# Snowtex Outerwear Ltd. (11803)

27.August.2014

# Identified Priority 1 Concerns

# 1st Priority 2 Concern

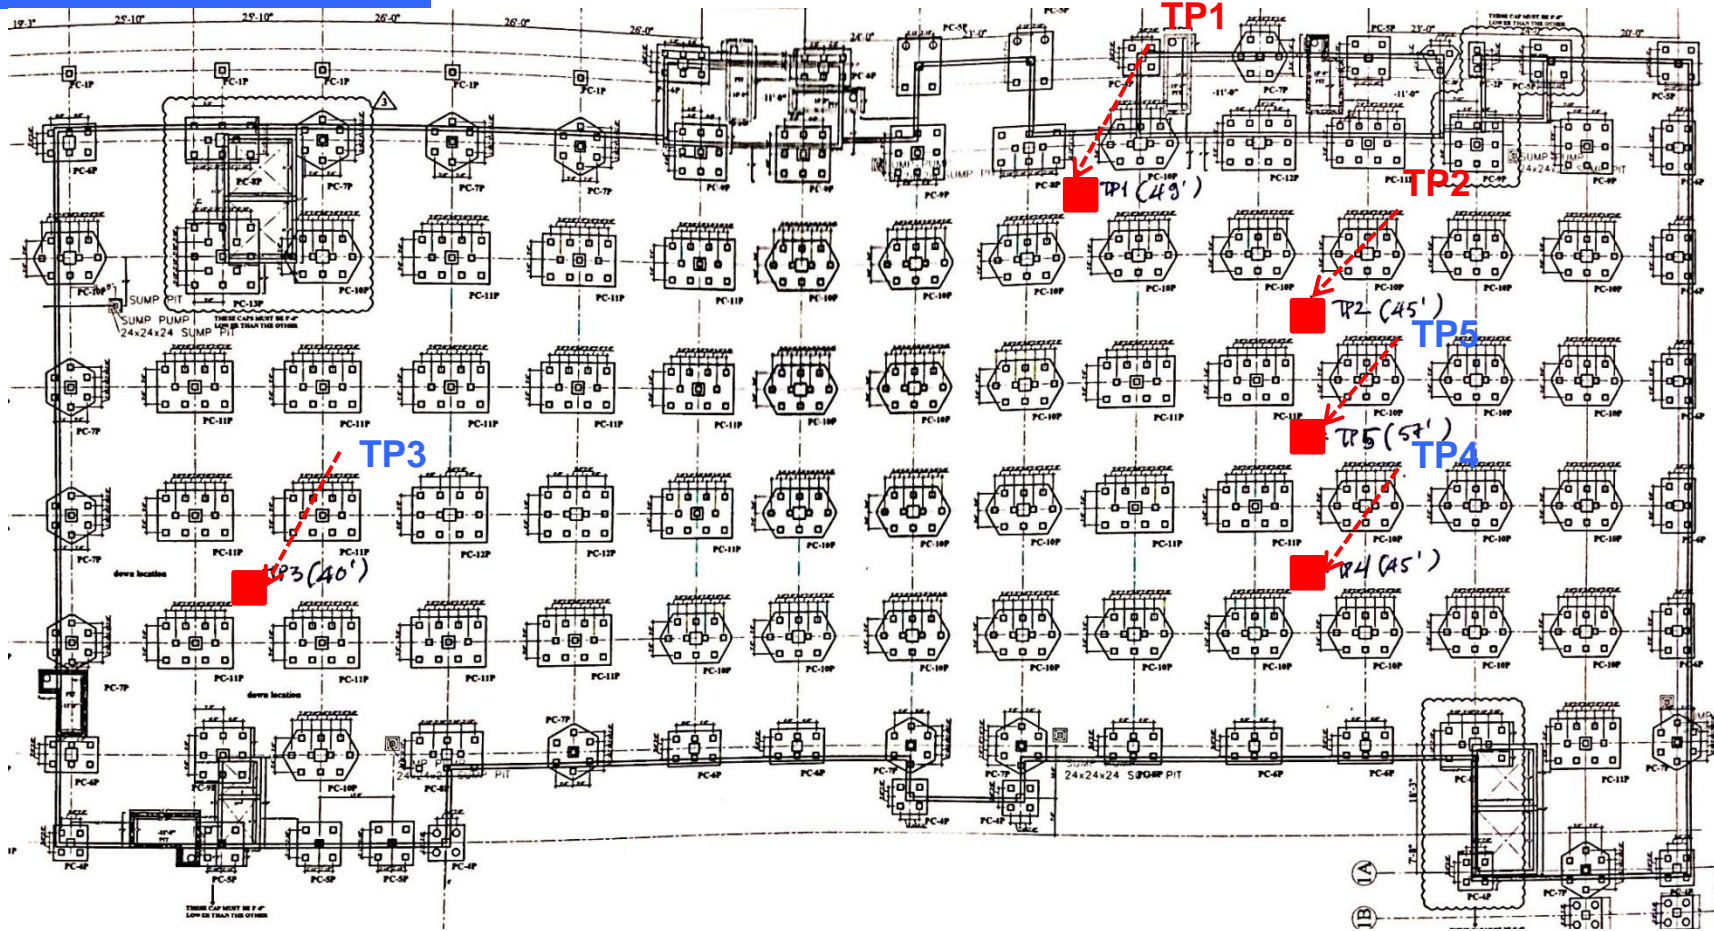
■ Test pile location

The foundations appear to be under designed with a pile capacity problem. See next page for details.

## 1<sup>st</sup> Priority 2 Concern (continued)

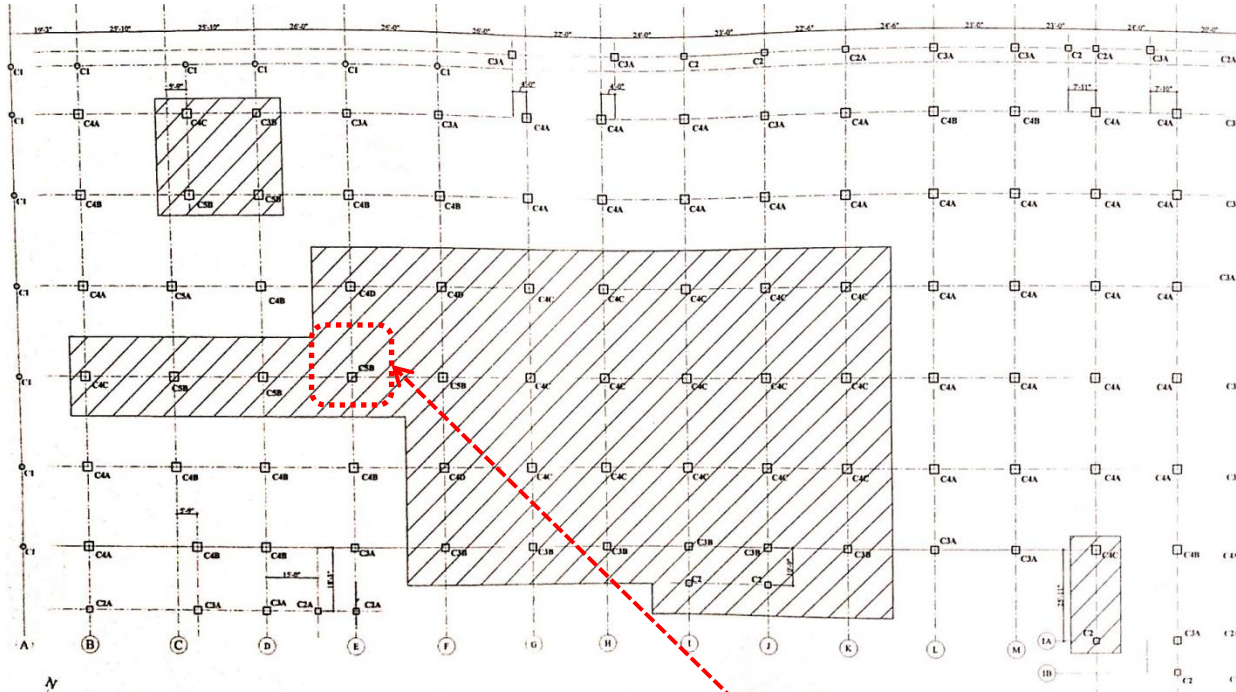
We suggest that the pile foundation should be carefully reviewed and checked again using the existing pile capacity at a 13.7m length.

The Building Engineer should then revise the foundation capacities and determine any implications on floor loading, or number of floors.

According to the Building Engineer and the Structural drawing, all the piles were driven to 13.7m. Therefore according to the soil report the pile design capacity is 55 Ton.

There are several problems with the soil report:

1. The test piles are not evenly spread over the building footprint.
2. The test piles are of different lengths.
3. The pile design loading does not consider the change in ground conditions throughout the site.
4. Test data was only provided for 3 piles.

## 5<sup>th</sup> Priority 2 Concern

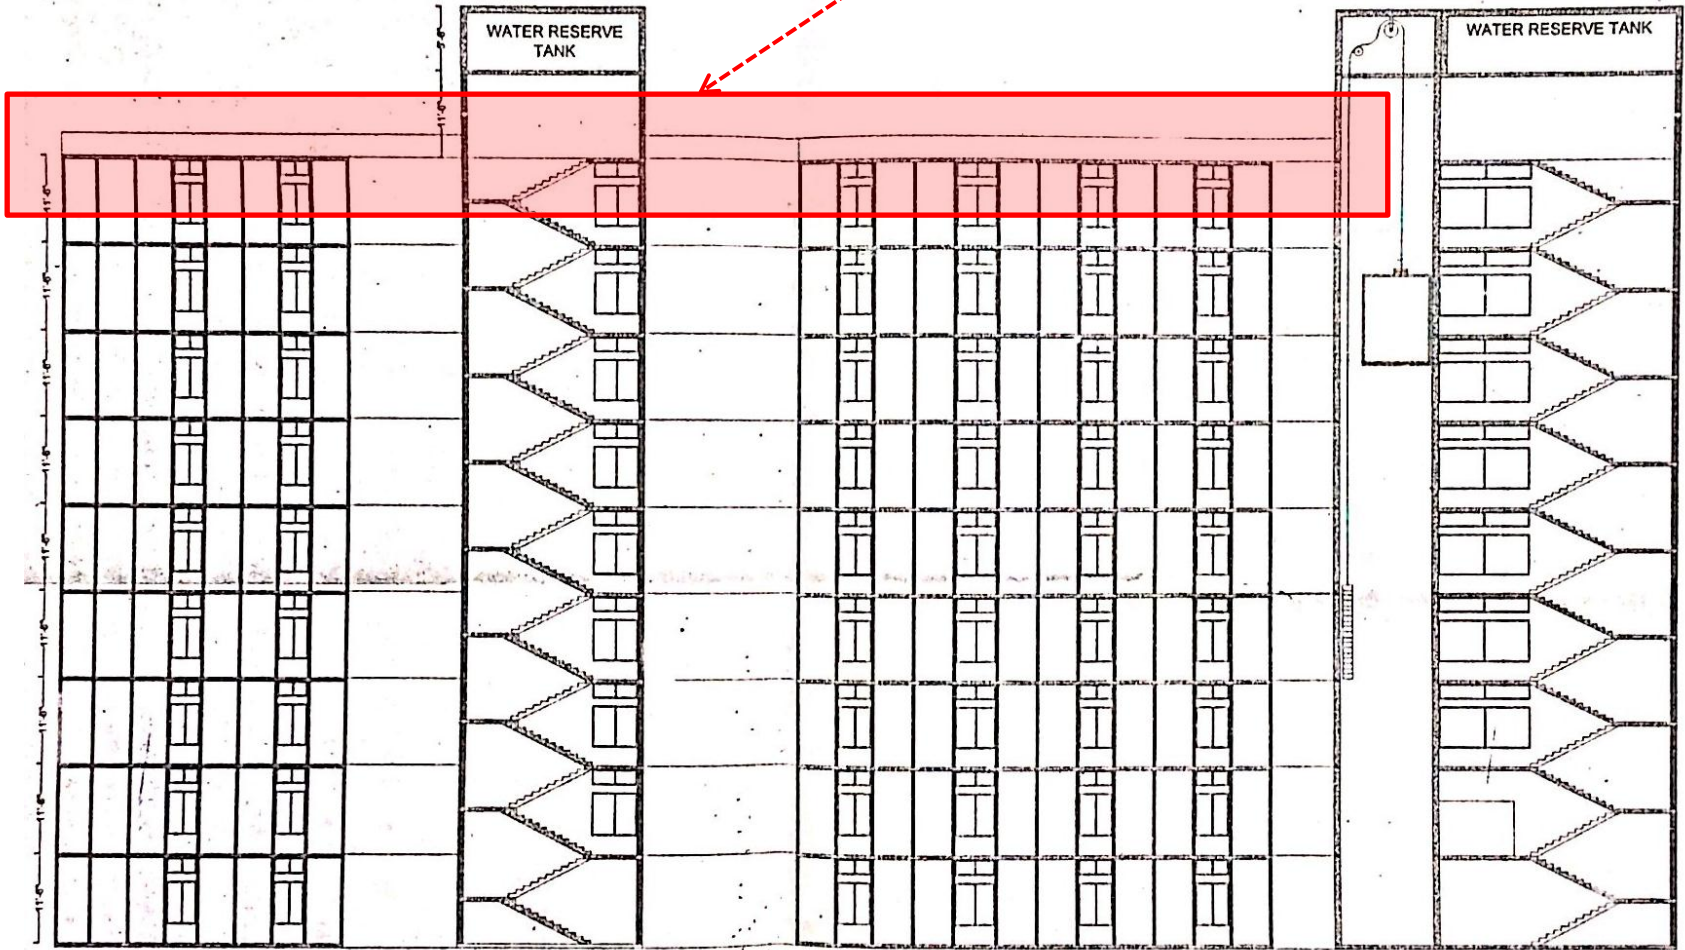
Several temporary buildings around the complex.
